ARM Group Inc.

Re: Response and Development Work Plan
Addendum
Area B: Sub-Parcel B5-1
Tradepoint Atlantic
Sparrows Point, MD 21219

Sub-Parcel B5-1 Original Proposed Development Boundary November 26, 2018		Figure 1
  ARM Group Inc. Engineers and Scientists	Tradepoint Atlantic Baltimore County, MD EnviroAnalytics Group ARM Project 160443M-10

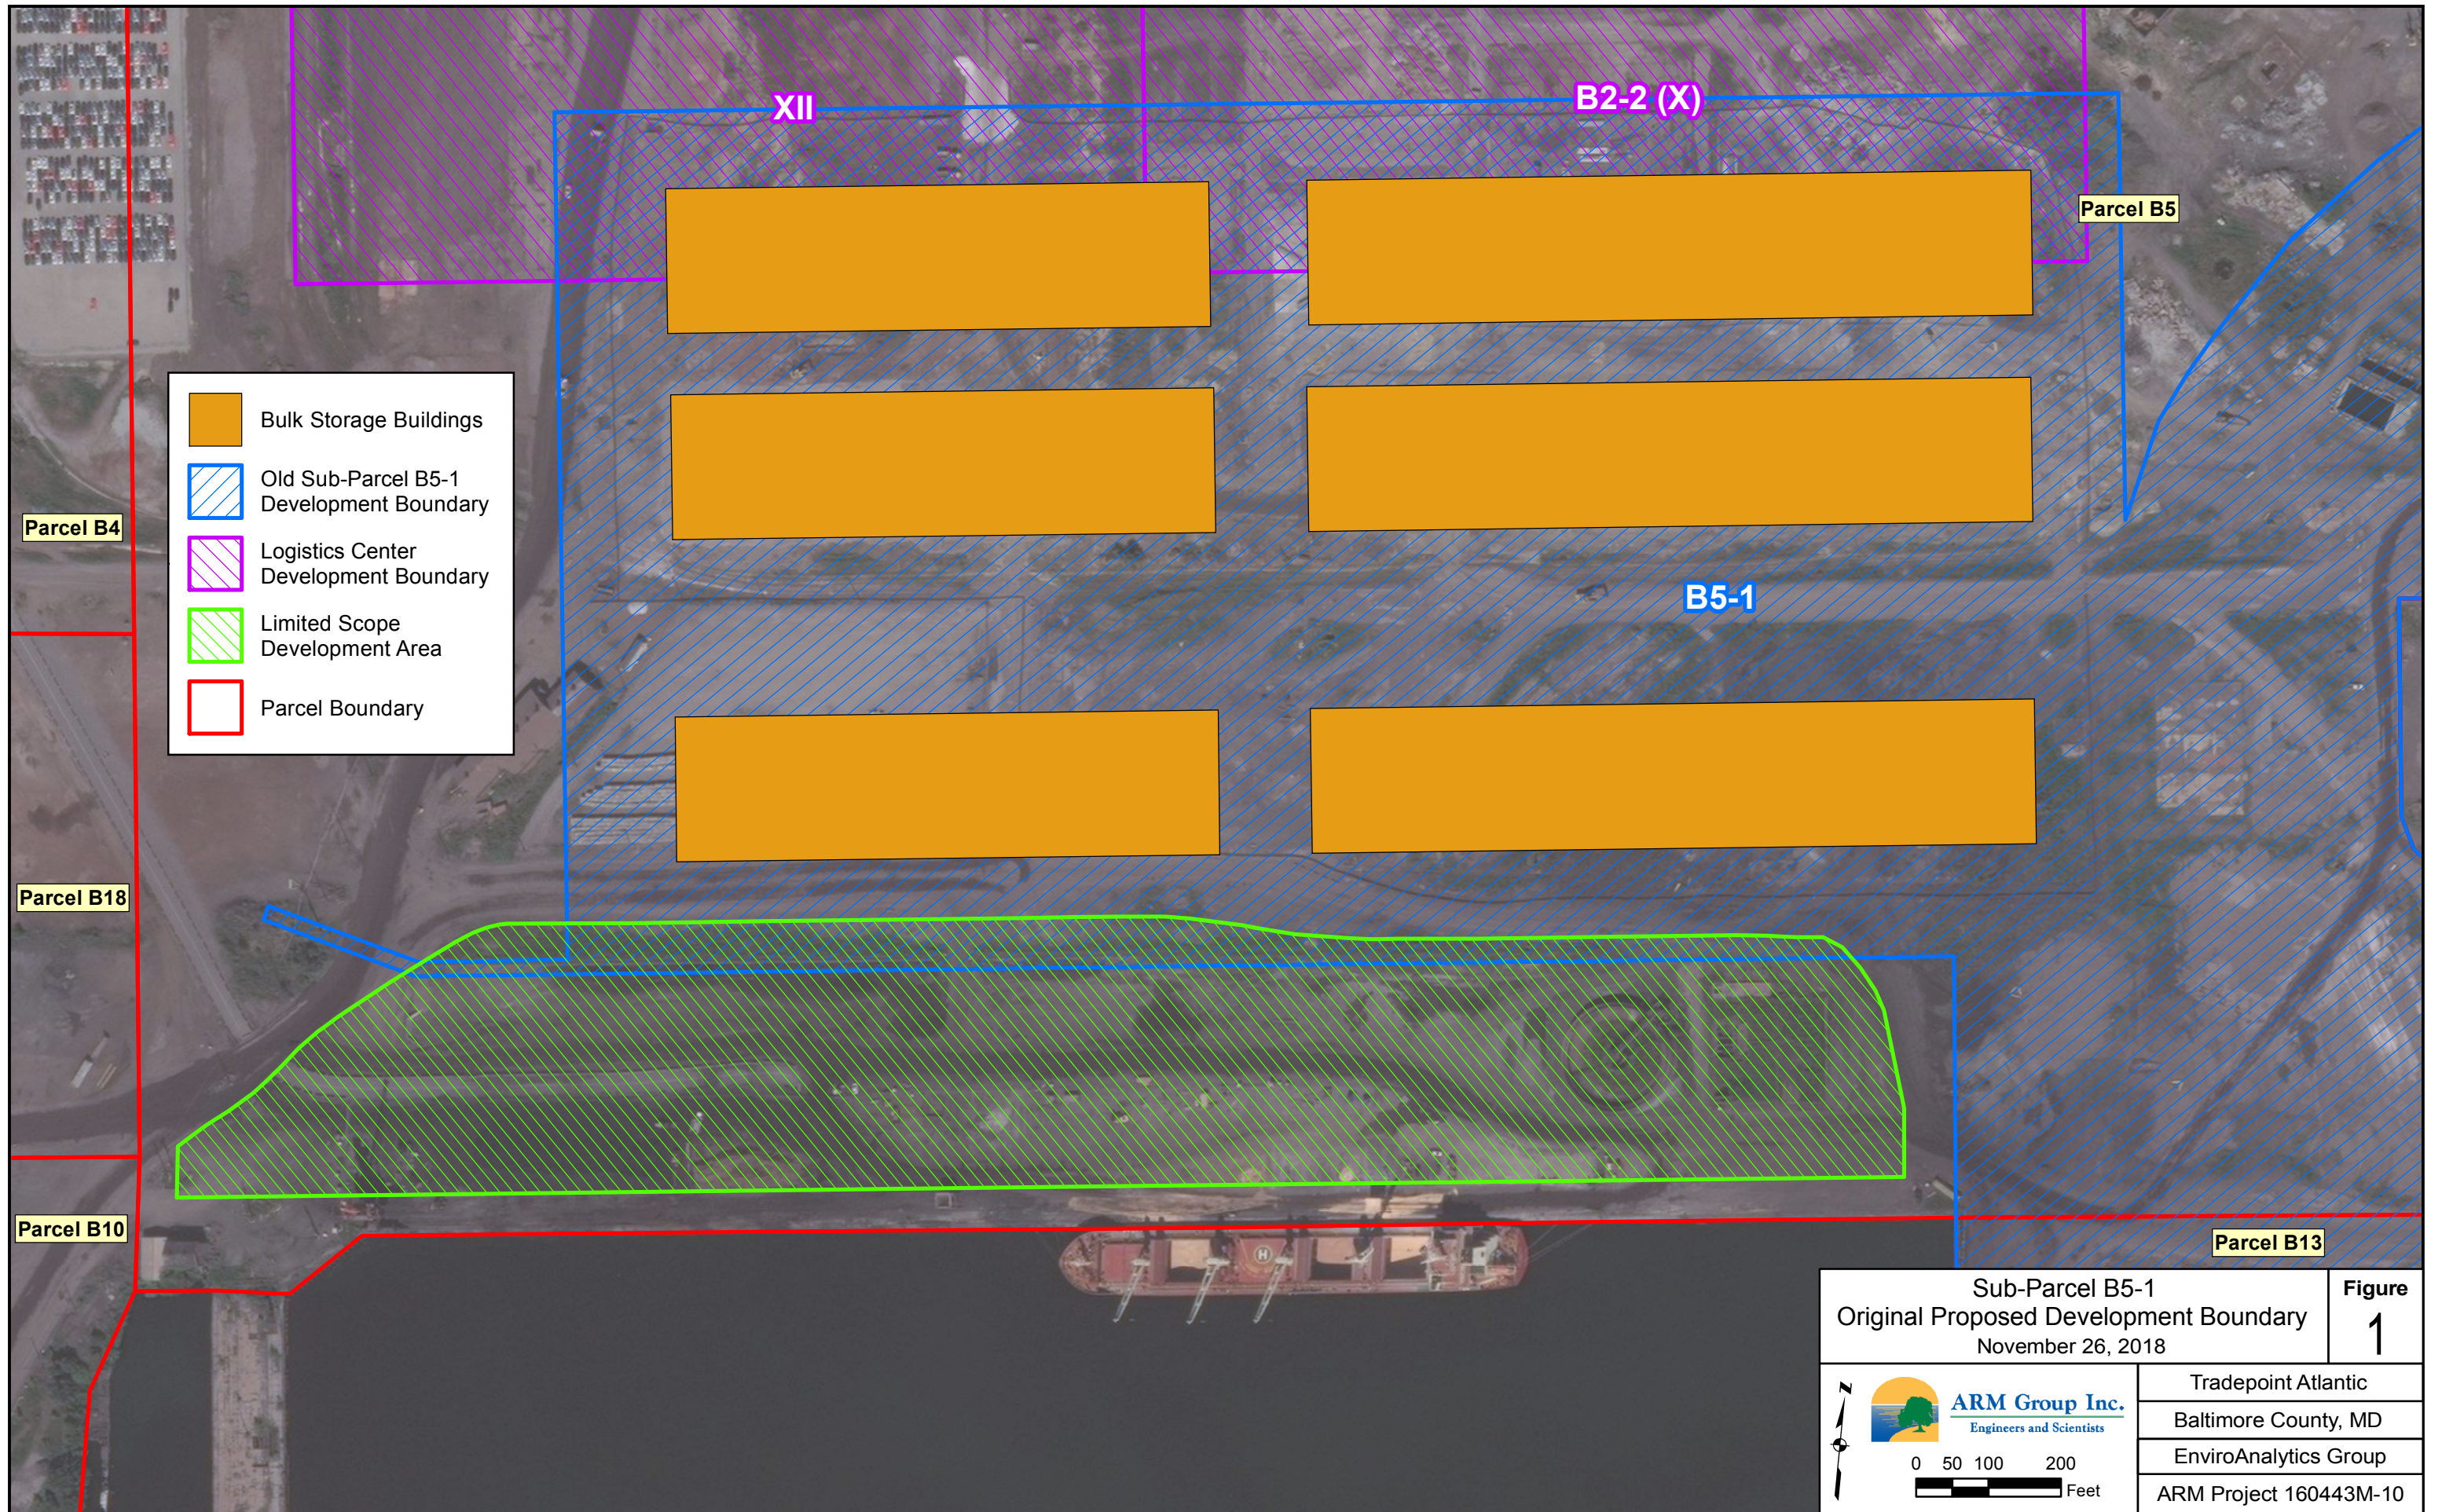
In the agency-approved RADWP, Sub-Parcel B5-1 was proposed to be approximately 124 acres and included six buildings. As can be seen on **Figure 1**, this original proposed development boundary overlaps with the more recent development areas designated as Logistic Center XII and Sub-Parcel B2-2 (Logistics Center X) along the northern Site boundary. There are approximately 11.5 acres of overlap between the original Sub-Parcel B5-1 boundary and the two Logistic Centers to the north. To eliminate this overlap at the northern boundary, the proposed area of Sub-Parcel B5-1 has been reduced to approximately 112.5 total acres as can be seen on **Figure 2**. To achieve this, the two northernmost buildings proposed within Sub-Parcel B5-1 have been removed from the plans. Between the proposed Logistic Centers X and XII and the current edge of pavement at the northern end of ongoing construction on Sub-Parcel B5-1, there

November 6, 2018		Figure 2

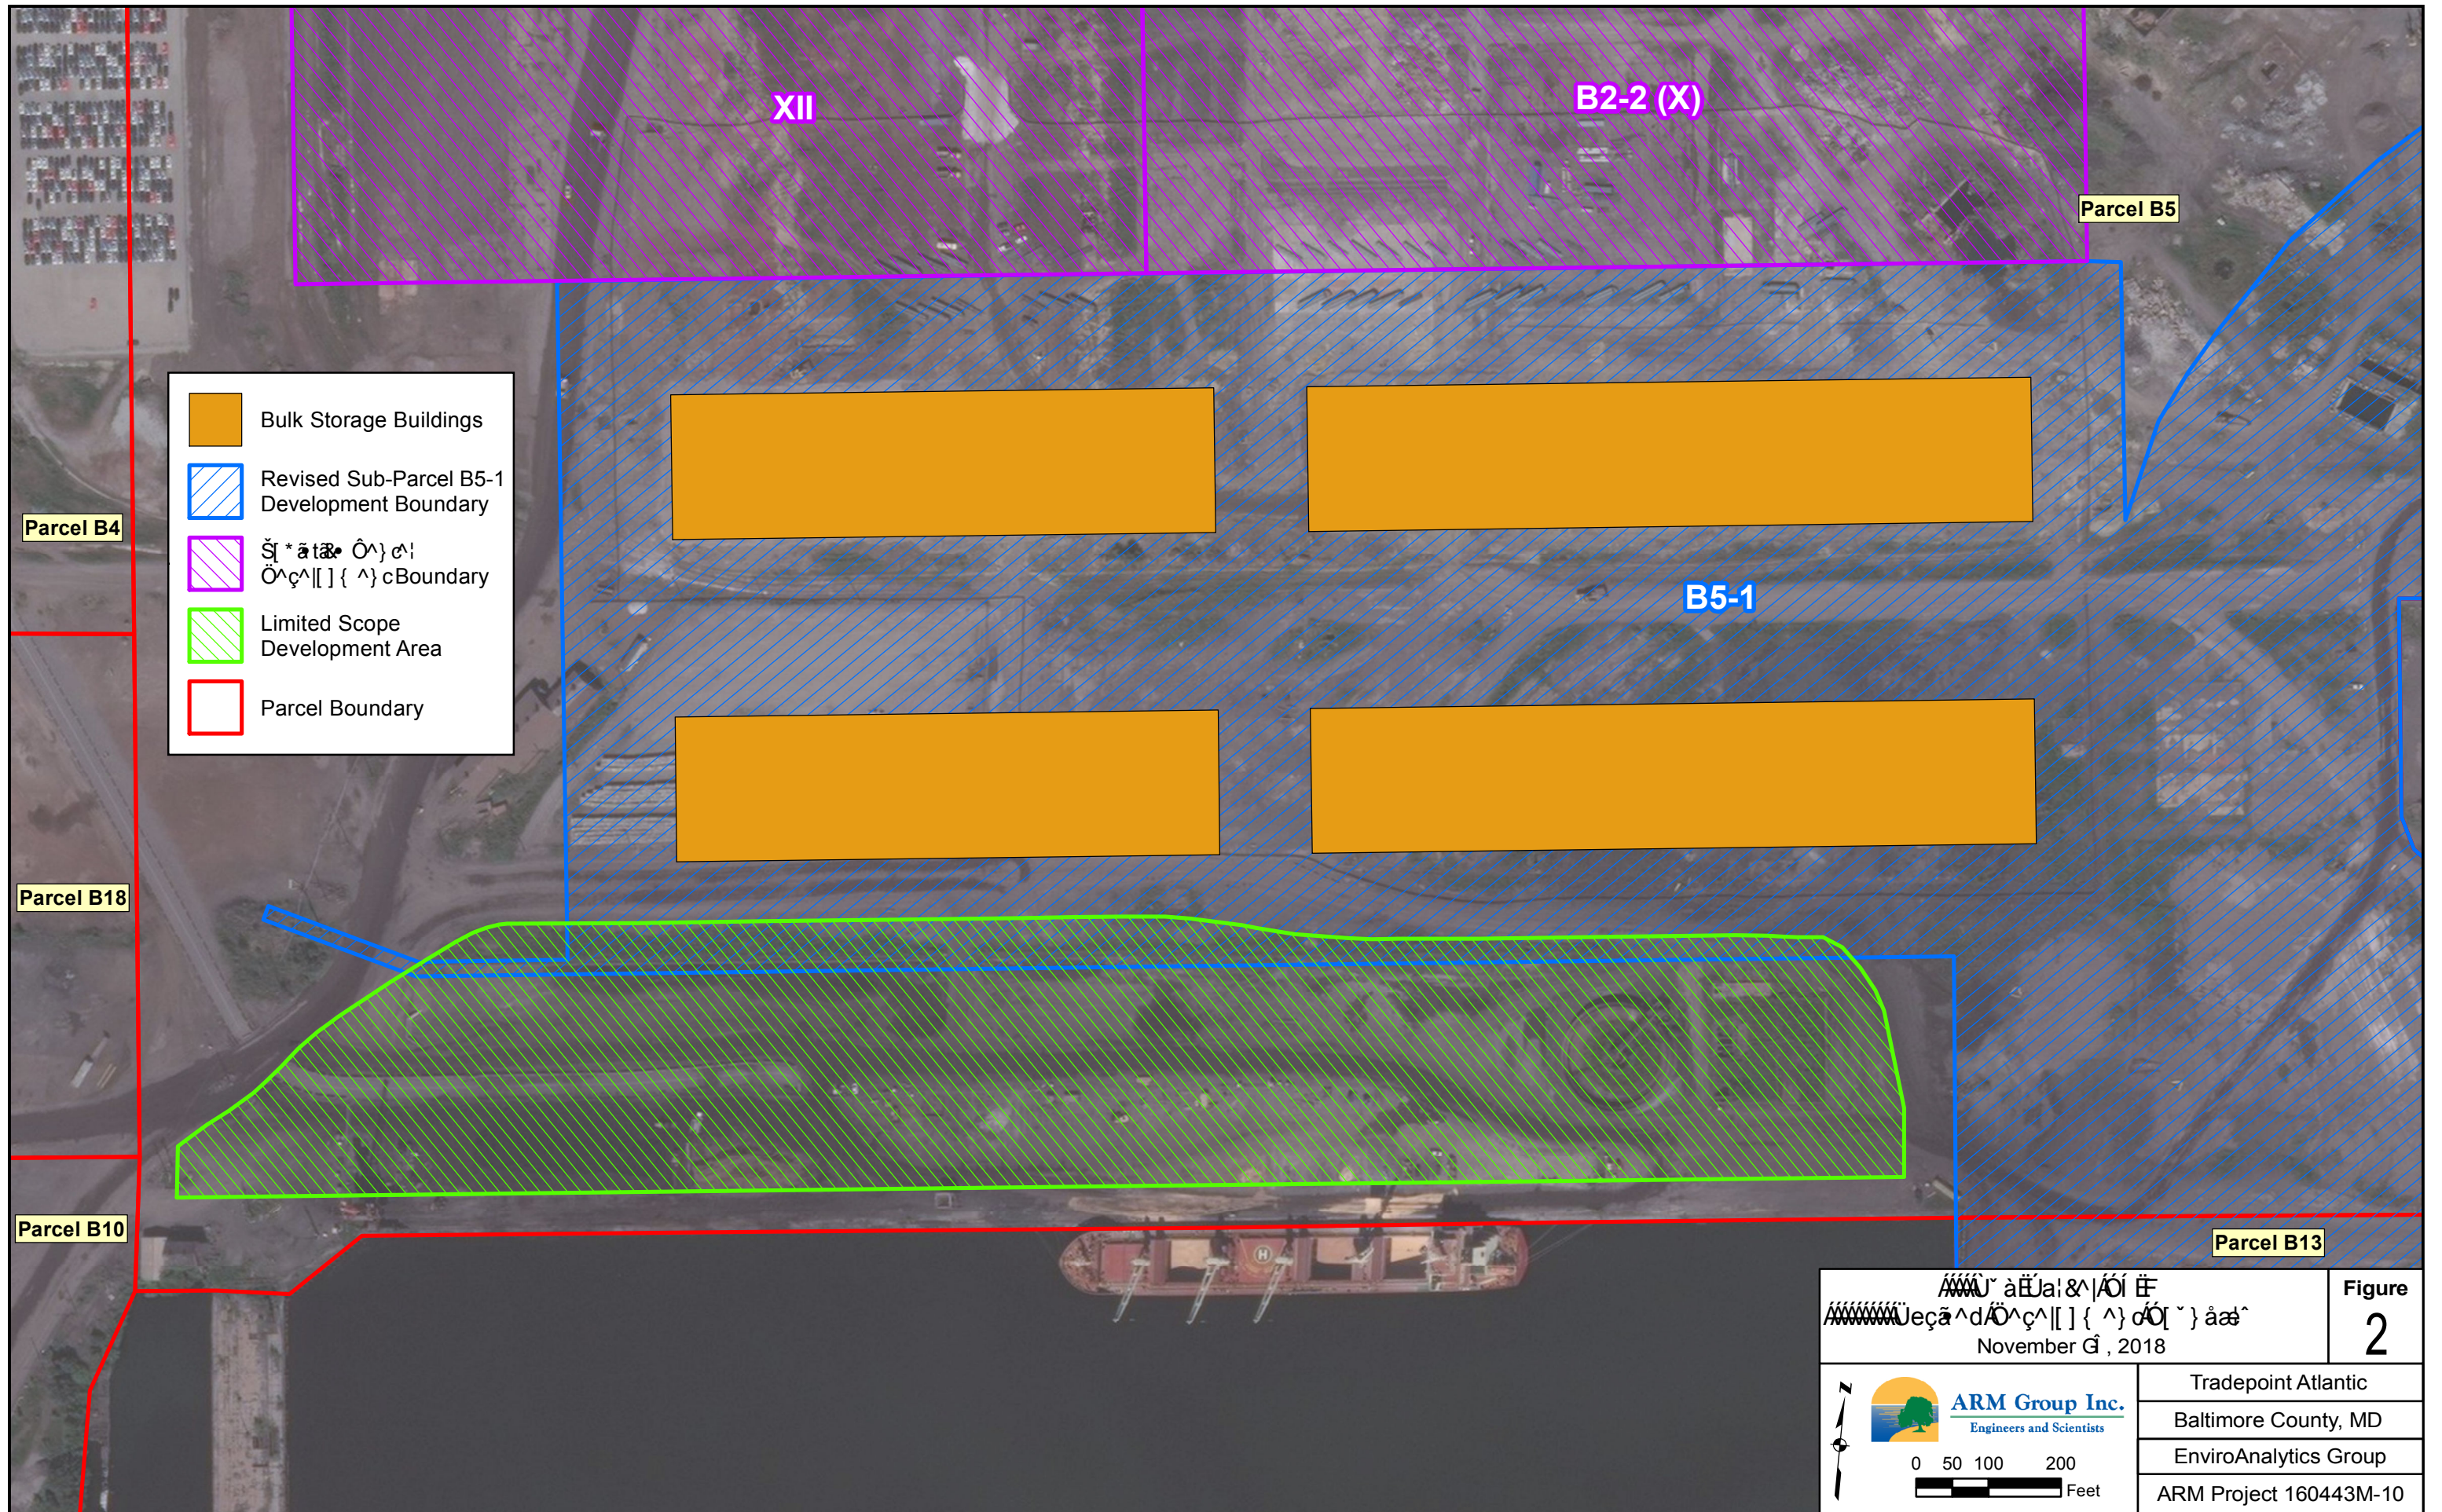
is an approximately 100-foot wide void space of unpaved land which is highlighted on **Figure 3**. Tradepoint Atlantic intends to install a segment of temporary fence near the edge of the existing asphalt (north of the two central buildings) in the short term. The temporary fence will define the interim northern boundary of the Site and restrict access to the uncapped area while development continues for Sub-Parcel B5-1 and the two Logistics Centers to the north. The void space will ultimately be capped by permanent surface engineering controls, which will be installed in accordance with the requirements of the MDE's Voluntary Cleanup Program (VCP).

At this time, the two central buildings on Sub-Parcel B5-1 have been completed, including a permanent capping remedy consisting of asphalt paving immediately around the two buildings. An interim remedy consisting of 4 inches of MDE-approved crushed concrete shall be placed on the remaining portions to the far east and west. The majority of the eastern quadrant of the southern portion of the Site has been paved with asphalt. The remaining areas of the incomplete southern portion of the Site shall be covered with an interim remedy consisting of a layer of 4 inches of MDE-approved crushed concrete, except as noted below. This new RADWP Addendum addresses certain changes to the interim capping remedy in the southern region of the Site that are a result of a separate project that will be implemented to the south of the Site.
